Sunset Garden Senior Living Apartments

Site Plan
A 236-Unit Apartment Project

Bradley Heights Apartments
Puyallup, Wa

CITY OF PUYALLUP
 Planning Division Approved Site Plan
 (253) 864-4185
 MINIMUM SETBACK REQUIREMENTS
 Front Yard: 10' Rear Yard: 0'
 Interior Side Yard: Left: 0' Right: 0'
 Street Side Yard: N/A
 Zoning District: RM-CORE
 Permit #: PRCP20260245
 Additional Conditions/Comments

SITE PLAN 236 UNITS

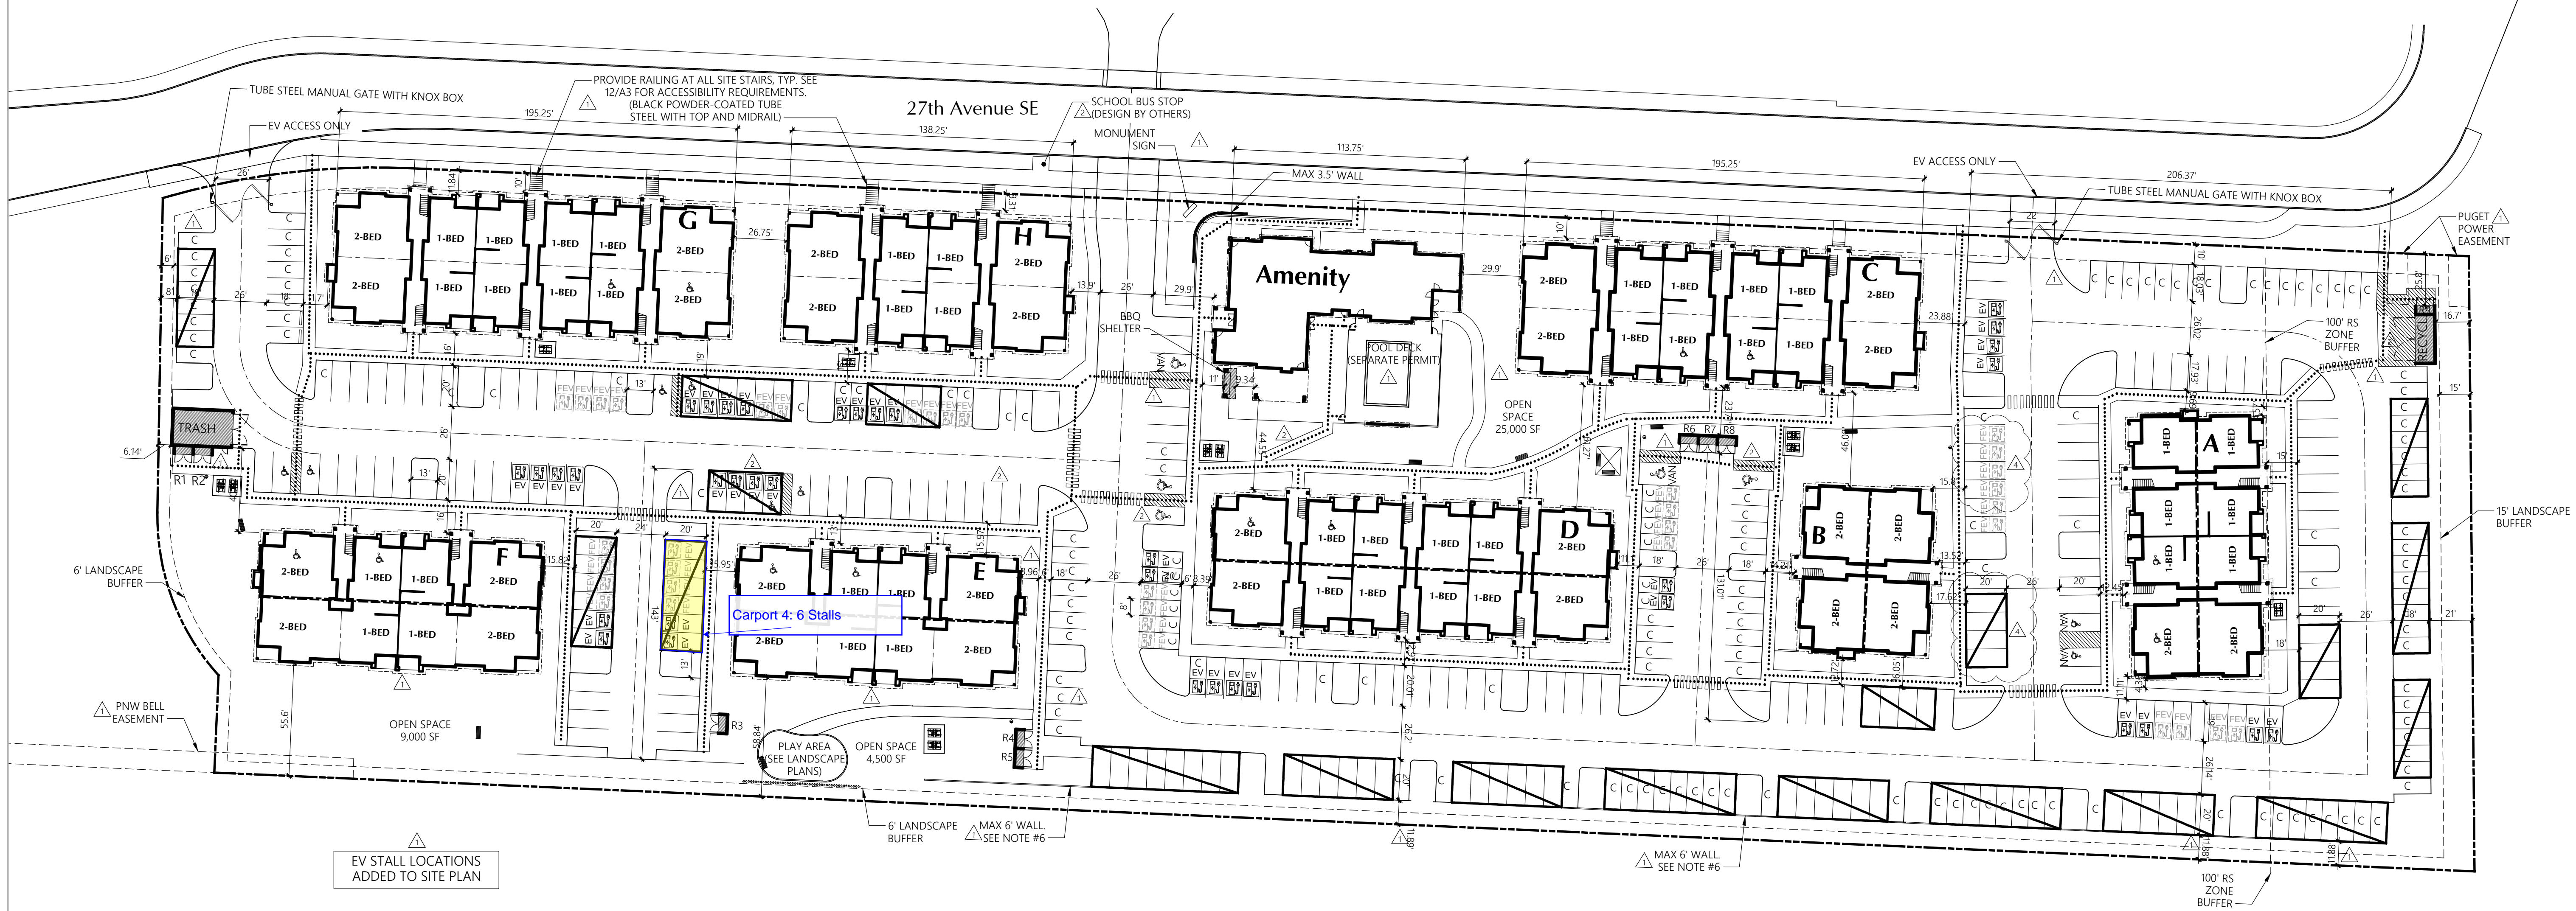
Roof downspout control is required. Steps shall be taken to prevent drainage onto adjacent lots. Refer to City standard details 02.05.01 & 02.05.05 for typical control methods. Stormwater runoff shall not concentrate to neighbors.

No proposed footings, posts, or supports shall be constructed on or above any existing public utility connections without first relocating the utility services or protecting it in place.

PARKING COUNTS CORRECTED
